[Docket No. FAA-2011-1231; Directorate Identifier 2011-NM-088-AD; Amendment 39-17418; AD 2013-08-01]

#### Airworthiness Directives; The Boeing Company Airplanes

**ACTION:** Final rule.

##### 2013-08-01 The Boeing Company:

Figure 1, Fastener Removal of the Retainer Support on the Left Thrust Reverser Half

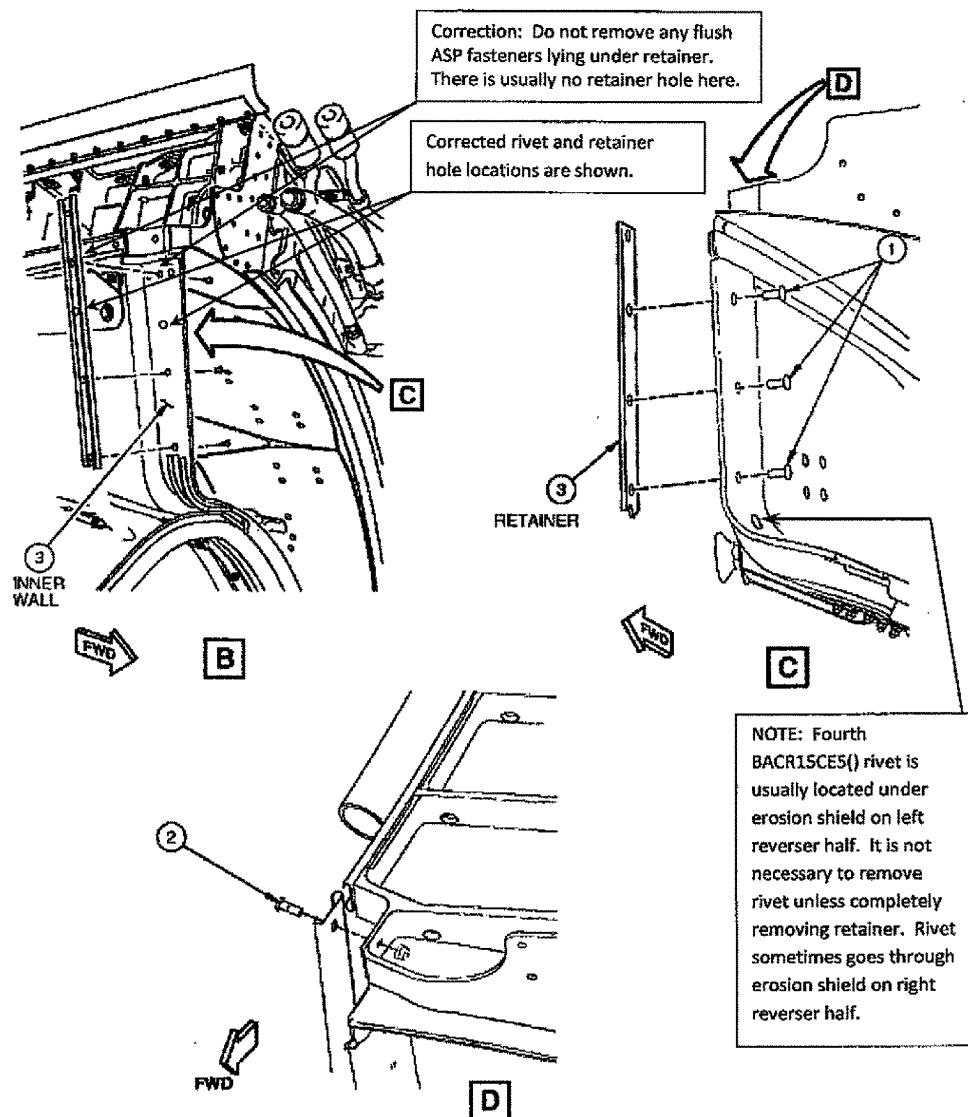
- Figures 6, 7, 15, and 16, all Sheet 2 of 3, all View B: These illustrations show the top fastener to be removed in the center of three fasteners in order to remove the retainer. However, these three fasteners are adjustable sustained preload (ASP) fasteners that do not require removal for this action. View B also incorrectly shows the location of the top rivet hole, which is actually below the row of ASP fasteners. These errors in those figures affect the actions specified in paragraph (g)(2) of this AD. The other instructions in the figures are correct.

(2) Figures 1 and 3 of this AD, titled "Fastener Removal of the Retainer Support on the Left (Right) Thrust Reverser Half," have View B showing the top fastener in the center of three adjustable sustained preload (ASP) fasteners. That top fastener does not require removal in order to remove the retainer. The figures in this AD point to the correct information for those fasteners.

Figure 2, Installation of the New Bracket behind the Retainer Support on the Left Thrust Reverser Half

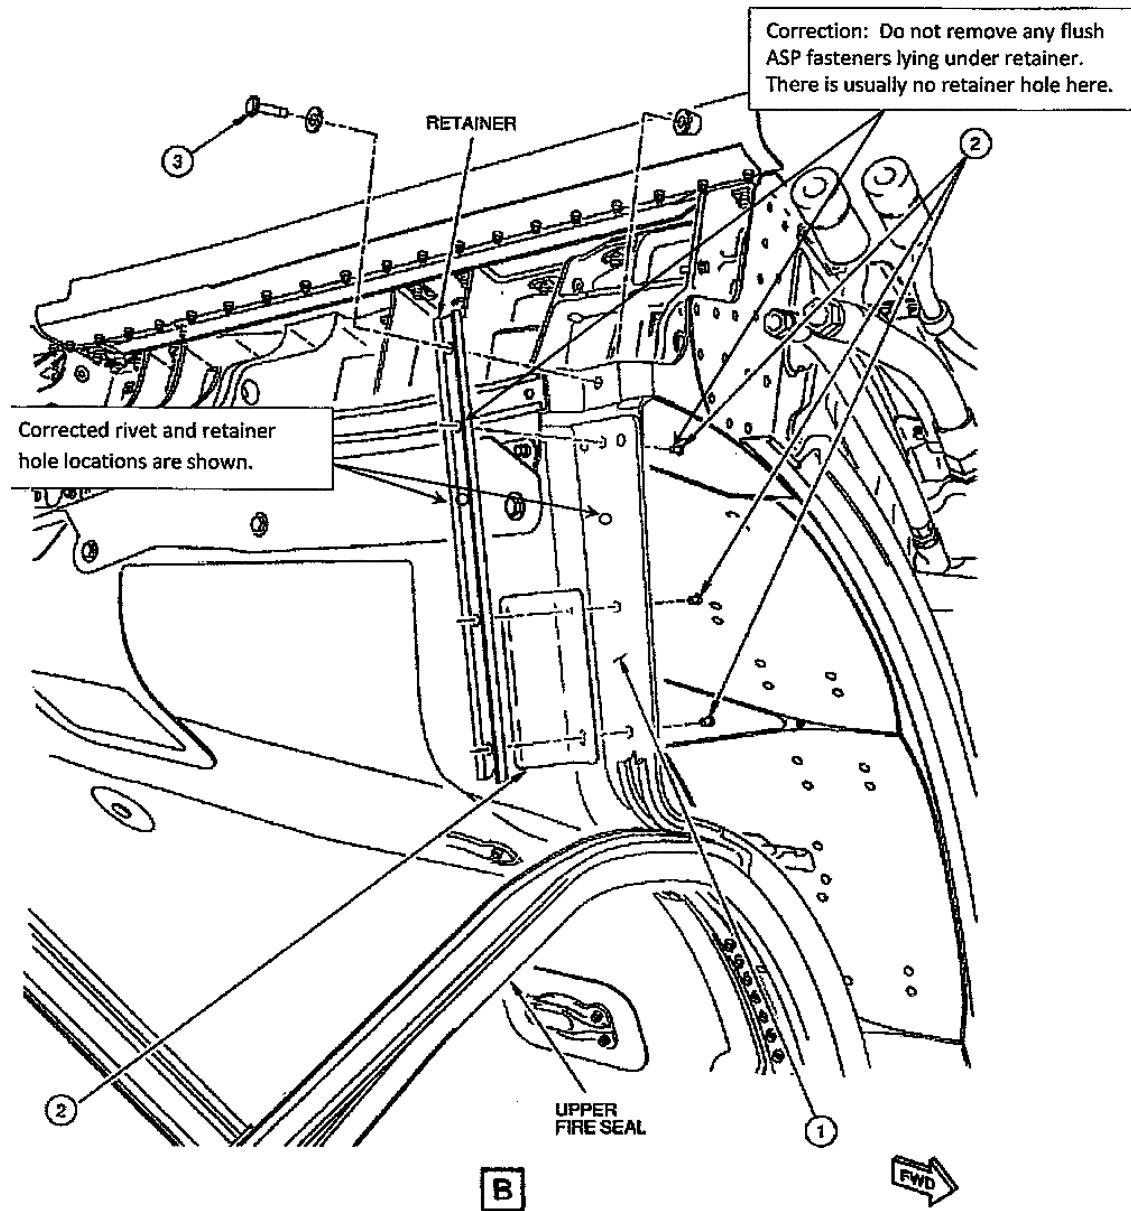
(3) Figures 2 and 4 of this AD, titled "Installation of the New Bracket behind the Retainer Support on the Left (Right) Thrust Reverser Half," have View B showing the top rivet hole. That rivet hole is actually below the row of three ASP fasteners. The figures in this AD point to the correct information for those rivet holes.
